**TWENTY-SECOND MEETING OF THE  
ASIA/PACIFIC AIR NAVIGATION PLANNING AND  
IMPLEMENTATION REGIONAL GROUP (APANPIRG/22)**

**Agenda Item 3:  
3.1**
**Performance Framework for Regional Air Navigation Planning  
and Implementation- AOP**
**AMENDMENT PROPOSALS TO ANNEX 14, VOLUME II**

- A — Proposed amendment to Annex 14, Volume II
- B — Response Form

**Figure 3-1. FATO and associated safety area**

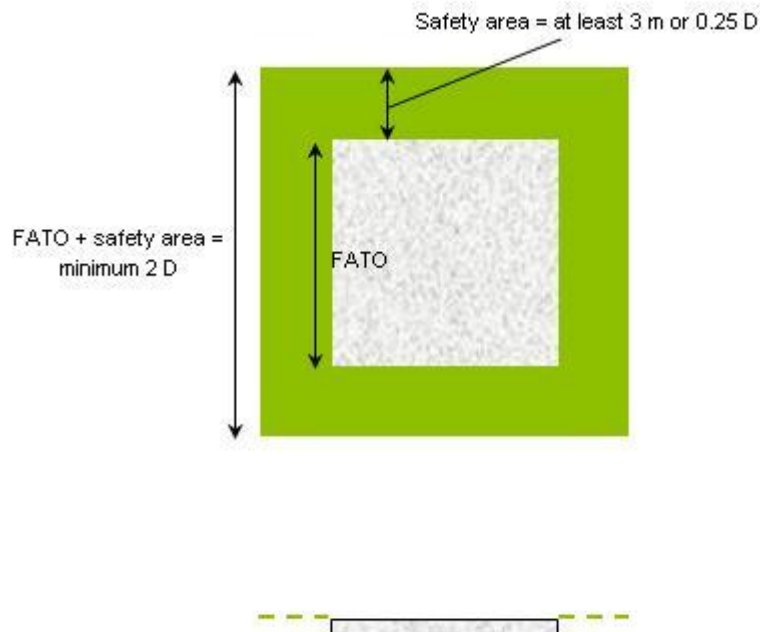
*Editorial Note.*— Replace Figure 3-1 with new Figure 3-1 as follows:  
(existing Figure 3-1 is relocated to Appendix 2 Figure A3-1)

**Figure 3-2. Helicopter ground taxi-route/taxiway**

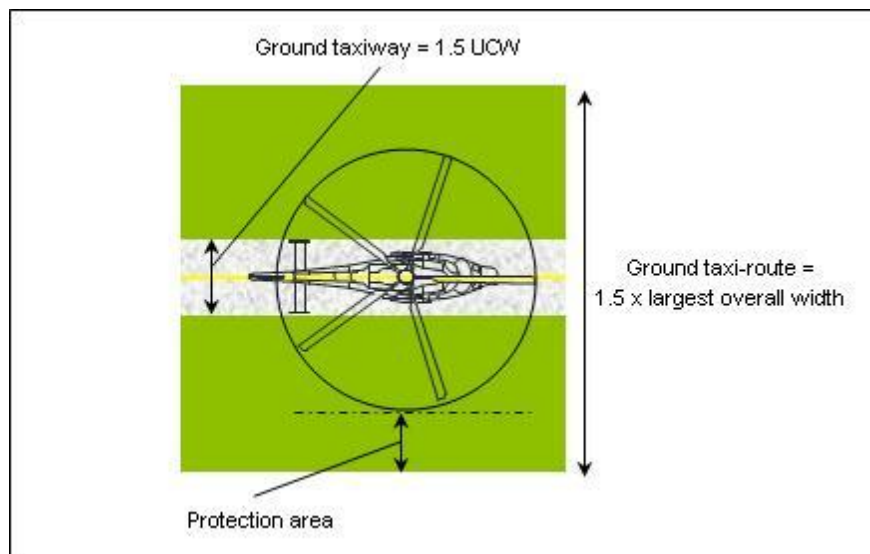
*Editorial Note.—* Replace Figure 3-2 with new Figure 3-2 as follows:

3.1.3029 The width of a helicopter ground taxiway shall not be less than 1.5 times the largest width of the undercarriage (UCW) of the helicopters the ground taxiway is intended to serve (see Figure 3-2).

**Figure 3-3. Helicopter air taxi-route/taxiway**

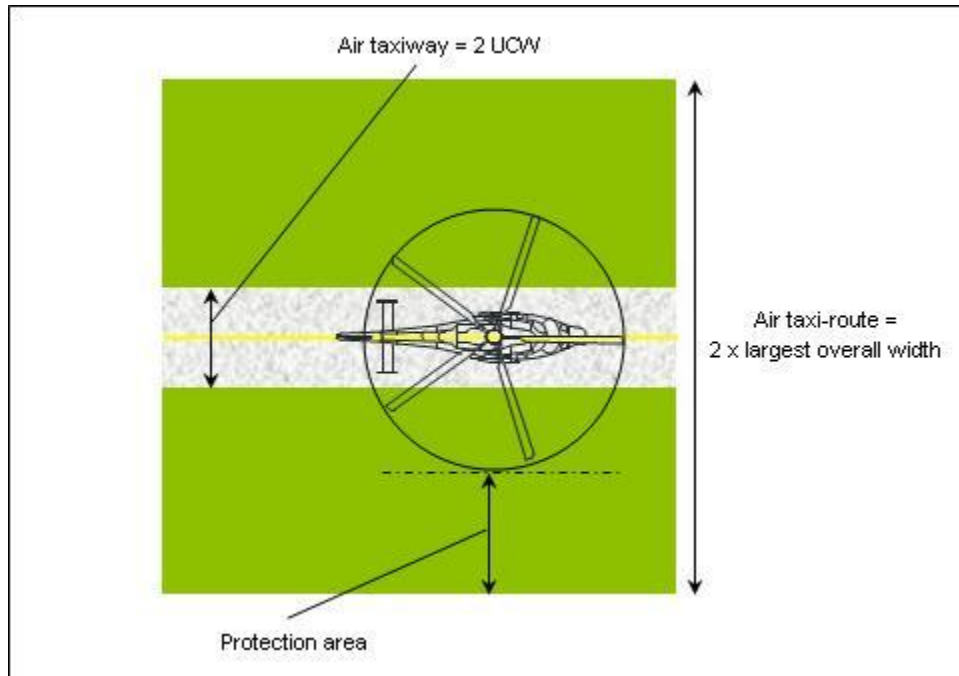
**Editorial Note.**— Replace Figure 3-3 with new Figure 3-3 as follows:

3.1.38~~39~~ The width of a helicopter air taxiway shall be at least two times the largest width of the undercarriage (UCW) of the helicopters that the air taxiway is intended to serve (see Figure 3-3).

**Figure 3-4. Helicopter stand and associated protection area**

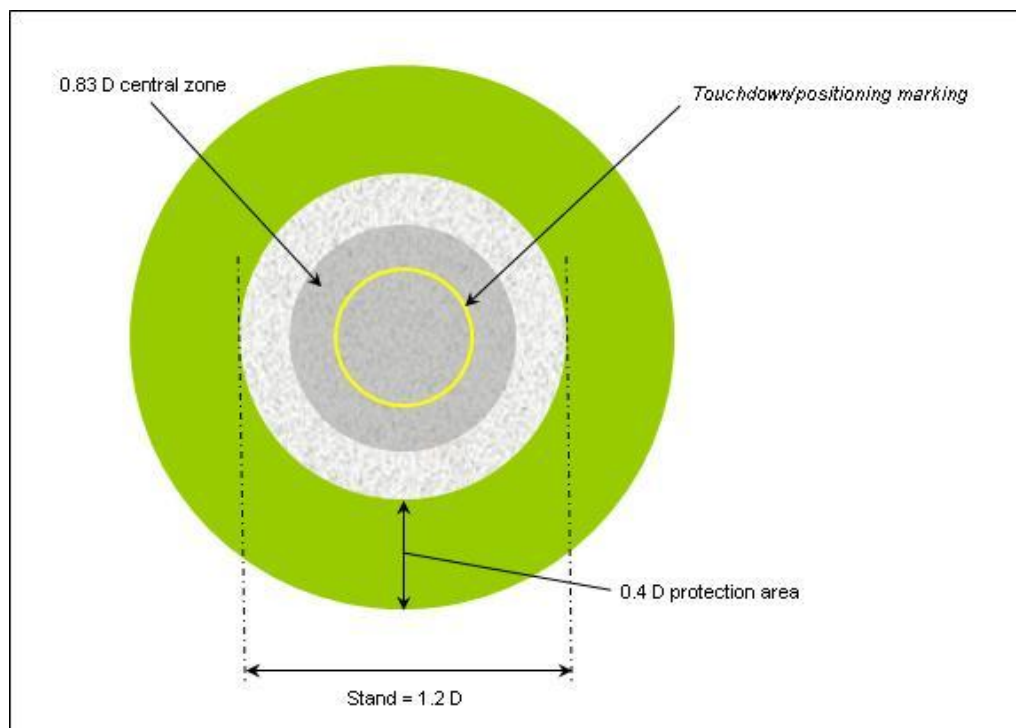
*Editorial Note.*— Replace Figure 3-5 with new Figure 3-4 as follows:

3.1.50~~52~~ A helicopter stand intended to be used by helicopters turning in a hover shall be of sufficient size to contain a circle of diameter of at least 1.2 D of the largest helicopter the stand is intended to serve (see Figure 3-4).

3.1.51~~53~~ ~~When~~ Where a helicopter stand is intended to be used for taxi-through and where the helicopter using the stand is not required to turn, the minimum width of the stand and associated protection area shall be that of the taxi-route (see Figure 3-4).

3.1.52~~54~~ ~~When~~ Where a helicopter stand is intended to be used for turning, the minimum dimension of the stand and protection area shall be not less than 2 D (see Figure 3-5).

**Figure 3-5. Helicopter stands designed for hover turns with air taxi-routes/taxiways — simultaneous operations**

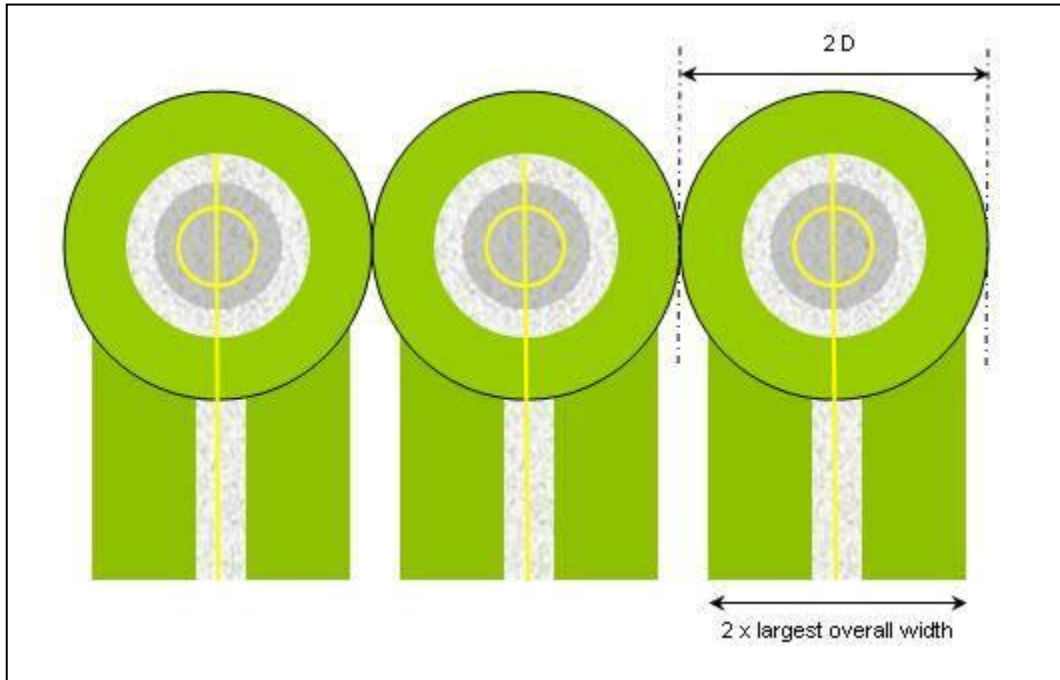
*Editorial Note.— Replace Figure 3-6 with new Figure 3-5 as follows:*

3.1.54~~56~~ For simultaneous operations, the protection areas of helicopter stands and their associated taxi-routes shall not overlap (see Figure 3-~~65~~).

**Figure 3-6. Helicopter stands designed for hover turns with**

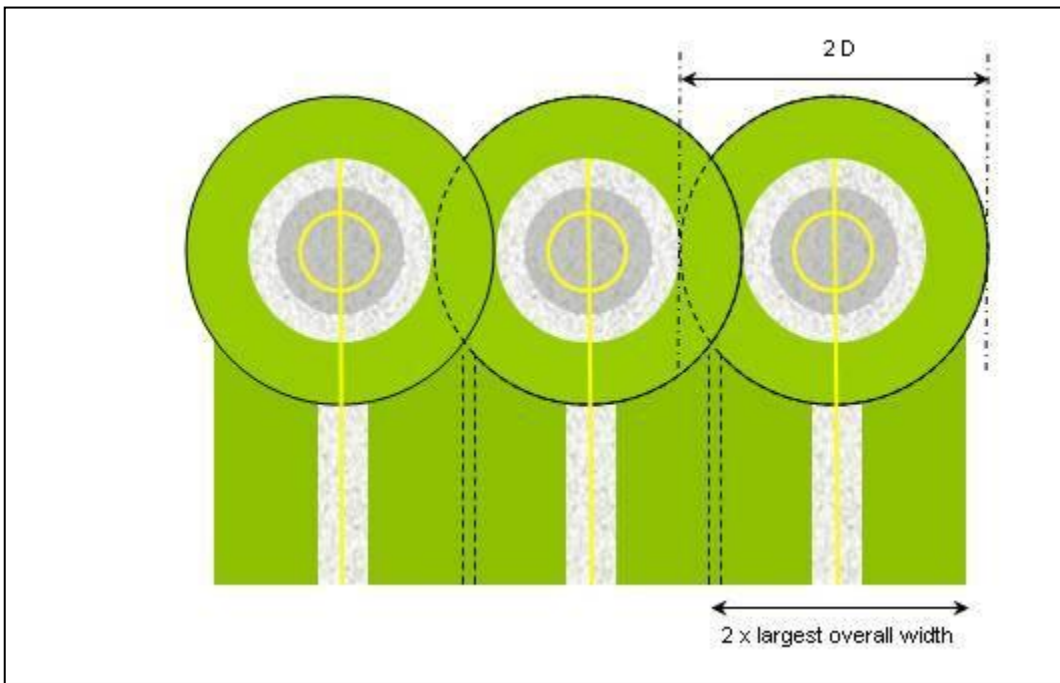
*Editorial Note.*— Replace Figure 3-7 with new Figure 3-6 as follows:

*Note.— Where non-simultaneous operations are envisaged, the protection areas of helicopter stands and their associated taxi-routes may overlap (see Figure 3-~~76~~).*

**Figure 3-7. FATO/TLOF and associated safety area**

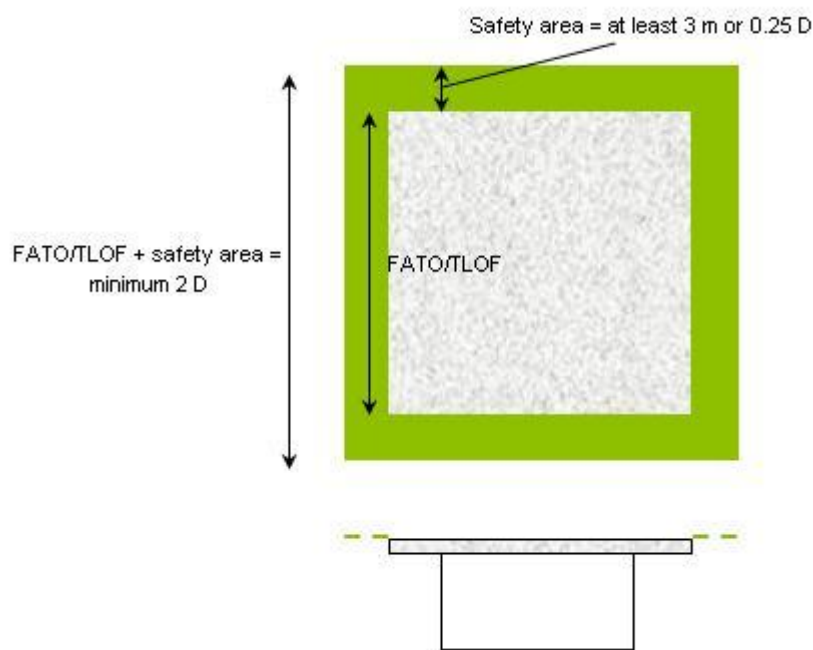
*Editorial Note.*— Insert new Figure 3-7 as follows:

3.2.11 **Recommendation.**— *The width of a helicopter clearway should not be less than that of the associated safety area (see Figure 3-7).*

**Figure 3-8. Helicopter ground taxi-route/taxiway**

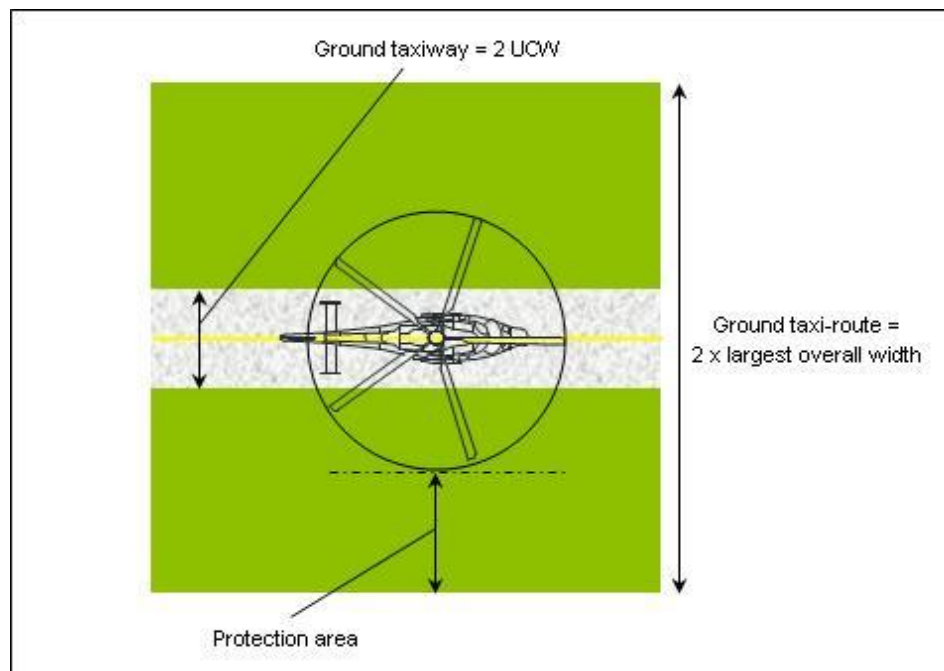
*Editorial Note.—* Insert new Figure 3-8 as follows:

3.2.3020 The width of a helicopter ground taxiway shall not be less than 2 times the largest width of the undercarriage (UCW) of the helicopters the ground taxiway is intended to serve (see Figure 3-8).

**Figure 3-9. Helicopter air taxi-route/taxiway**

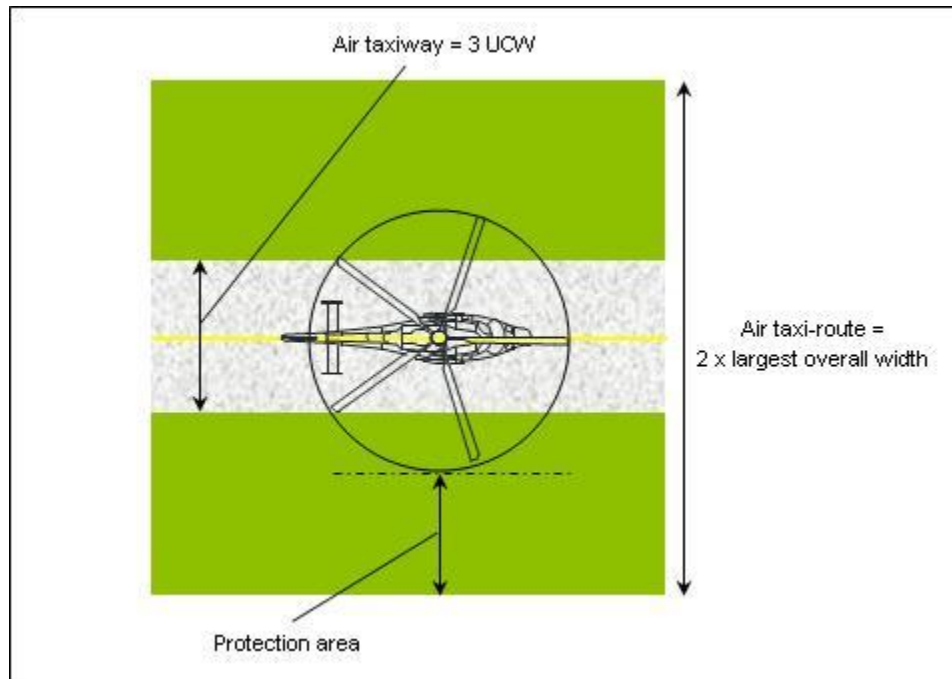
*Editorial Note.*— Insert new Figure 3-9 as follows:

3.2.38<sup>30</sup> The width of a helicopter air taxiway shall be at least three times the largest width of the undercarriage (UCW) of the helicopters the air taxiway is intended to serve (see Figure 3-9).

Figure 4-8. Helideck obstacle limitation sectors and surfaces for a 1D FATO/TLOF

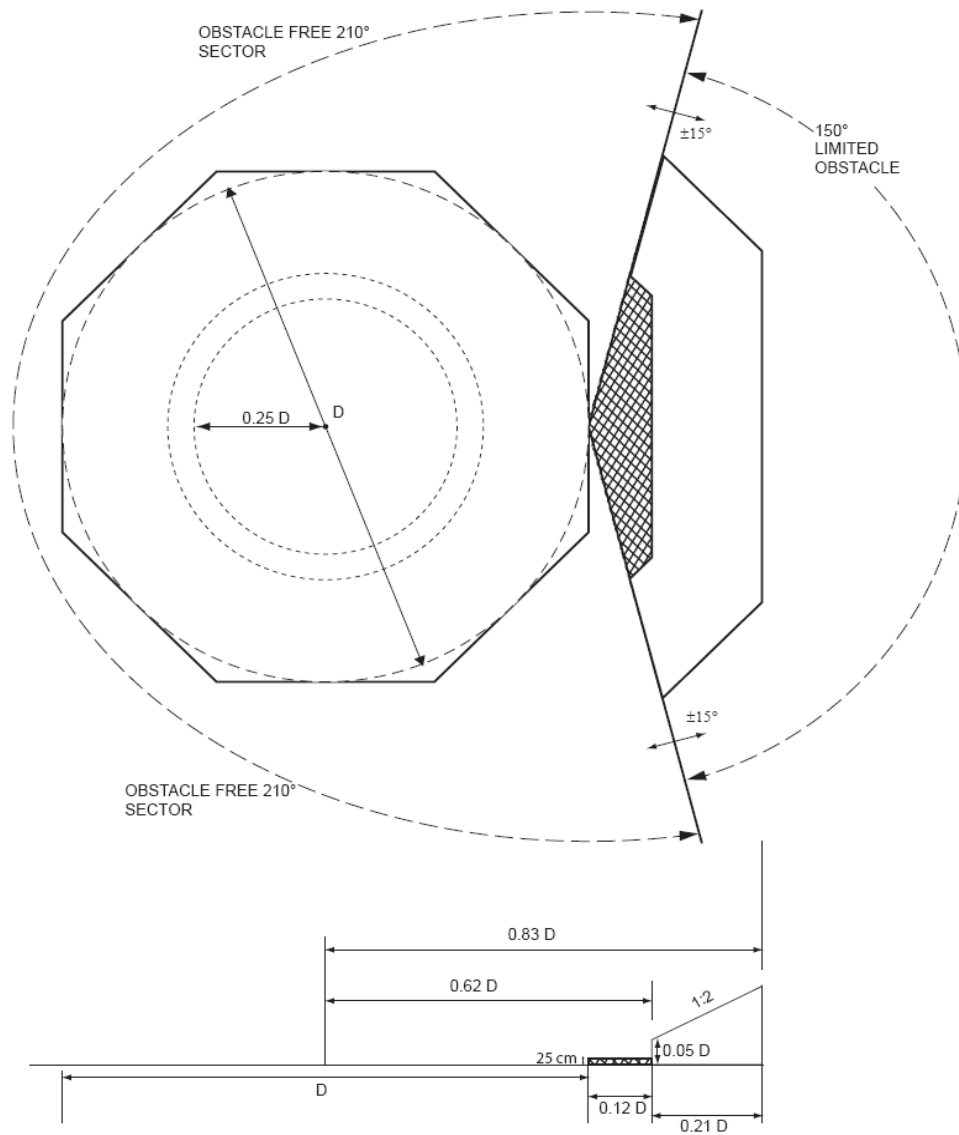
*Editorial Note.* Delete existing Figure 4-3. Add new Figure 4-8. Helideck obstacle limitation sectors and surfaces for a 1D FATO/TLOF.

4.2.16 For a FATO/TLOF of 1D and larger, within the 150-degree limited obstacle surface/sector out to a distance of 0.62D, measured from the centre of the FATO, 0.12D measured from the point of origin of the limited obstacle sector, objects shall not exceed a height of 0.05D 25 cm above the FATO/TLOF. Beyond that arc, out to an over-all distance of 0.83D a further 0.21D measured from the end of the first sector, the limited obstacle surface rises at a rate of one unit vertically for each two units horizontally originating at a height 0.05D above the level of the FATO/TLOF (see Figure 4-38 which illustrates the surfaces/ sectors for a 1D FATO/TLOF).

Figure 4-9. Helideck obstacle limitation sectors and surfaces for a 0.83D FATO/TLOF

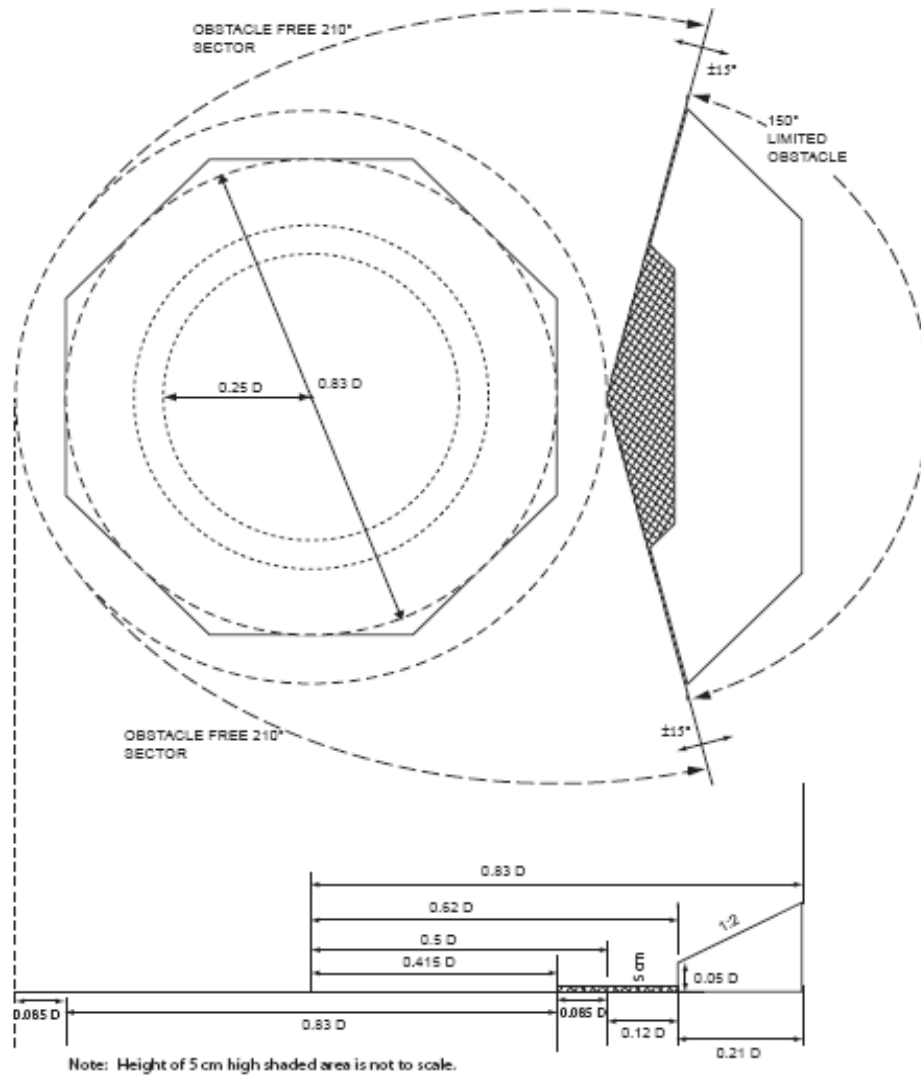
A FATO/TLOF for a helicopter with a MTOM of 3175 kg or less may accommodate a circle of diameter less than 1D, but not less than 0.83D (3.3.3b refers). Up until now there has not been a Figure presentation displaying sectors and surfaces for the 0.83D minimum size arrangement and it is considered that this information is very useful, if not essential, for designers of 0.83D helidecks. A scheme showing the sectors and surfaces for a 0.83D FATO/TLOF is presented as Figure 4-9.

Beyond that arc, out to an overall distance of 0.83D from the centre of the FATO/TLOF, the limited obstacle surface rises at a rate of one unit vertically for each two units horizontally originating at a height 0.05D above the level of the FATO/TLOF (see Figure 4-9 which illustrates the surfaces / sectors for a 0.83D FATO/TLOF).

**Figure 5-1. Combined heliport identification and aiming point marking**

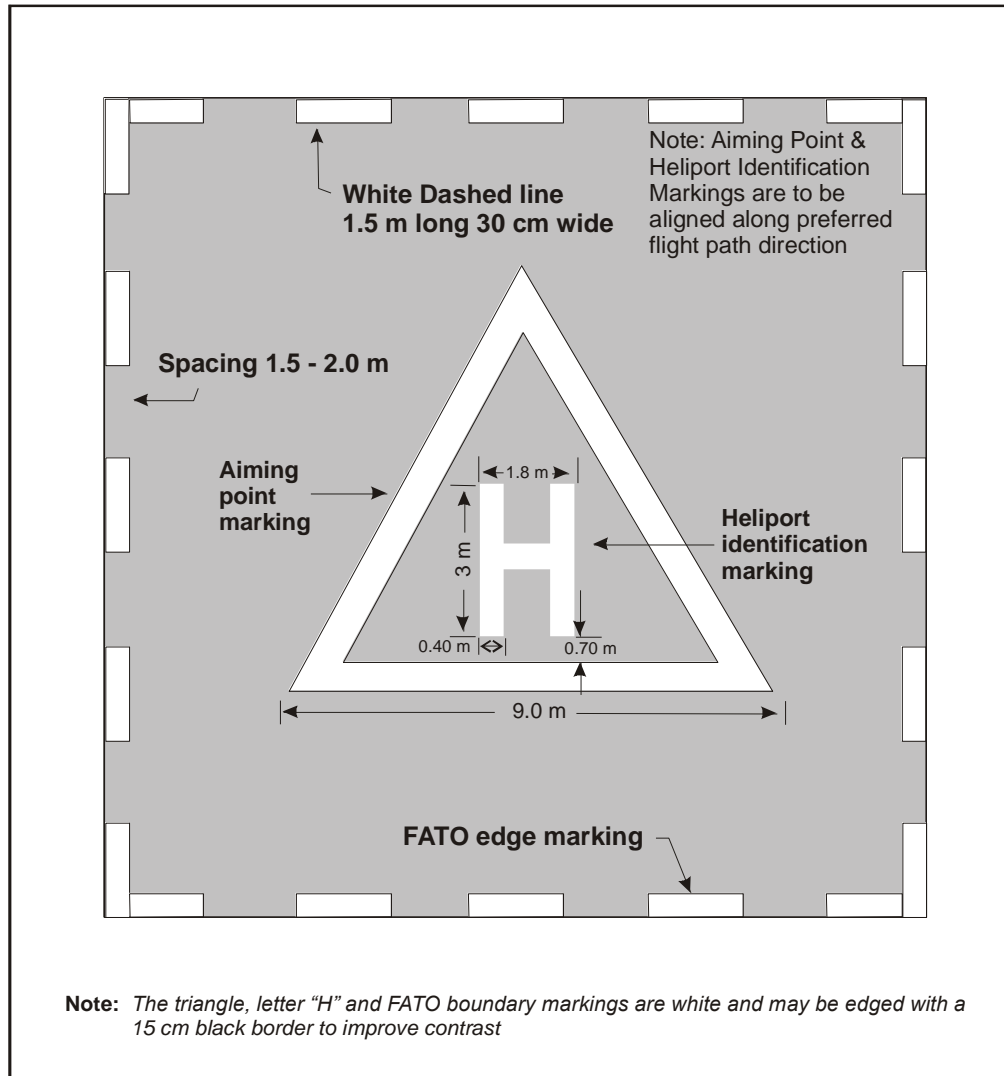
*Editorial Note.—* Replace figure 5-1 with new Figure 5-1 as follows:

*Note 2.- On a FATO, which does not contain a TLOF and which is marked with an aiming point marking (see 5.2.8), except for a heliport at a hospital, the heliport identification marking is established in the centre of the aiming point marking as shown in Figure 5-1.*

**Figure 5-2. Hospital heliport identification and heliport identification marking**

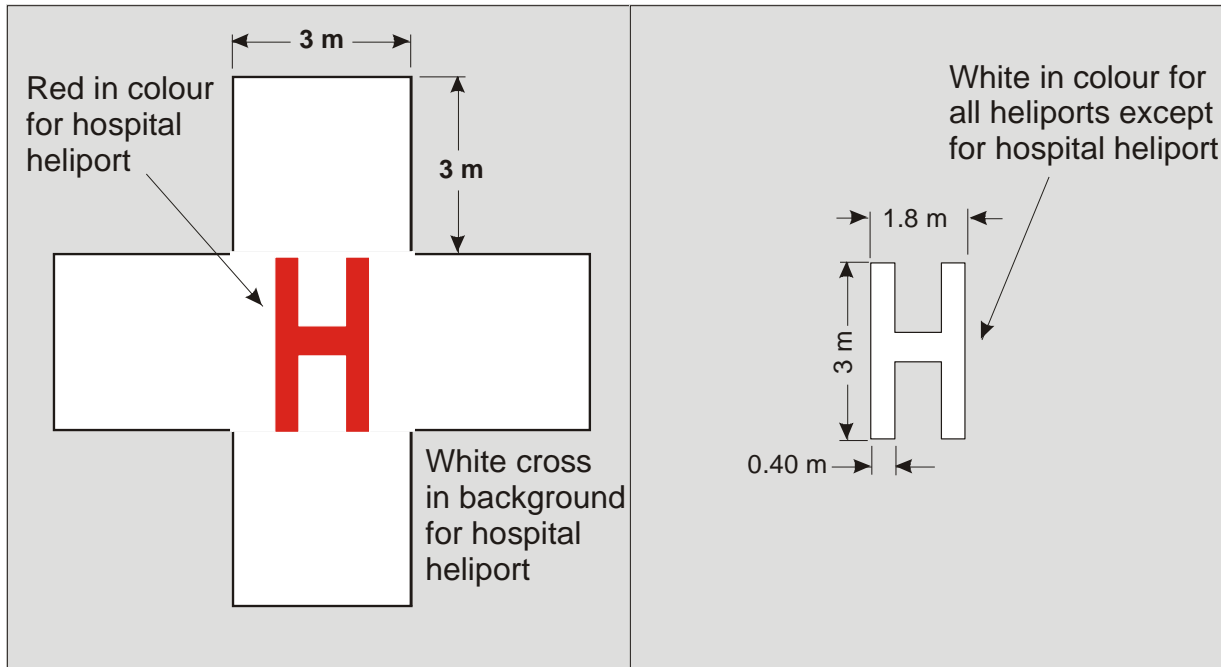
*Editorial Note.*— Replace Figure 5-2 with new Figure 5-2 as follows:

5.2.2.46 A heliport identification marking for a heliport at a hospital shall consist of a letter H, red in colour, on a white cross made of squares adjacent to each of the sides of a square containing the H as shown in Figure 5-2.

**Figure 5-5 Runway-type FATO edge marker**

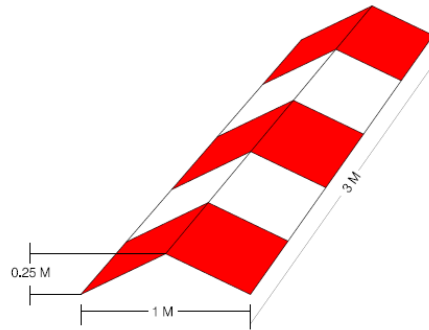
*Editorial Note.— New Figure 5-5:*

5.2.6.6 A FATO perimeter marker shall have dimensional characteristics as shown in Figure 5-5.
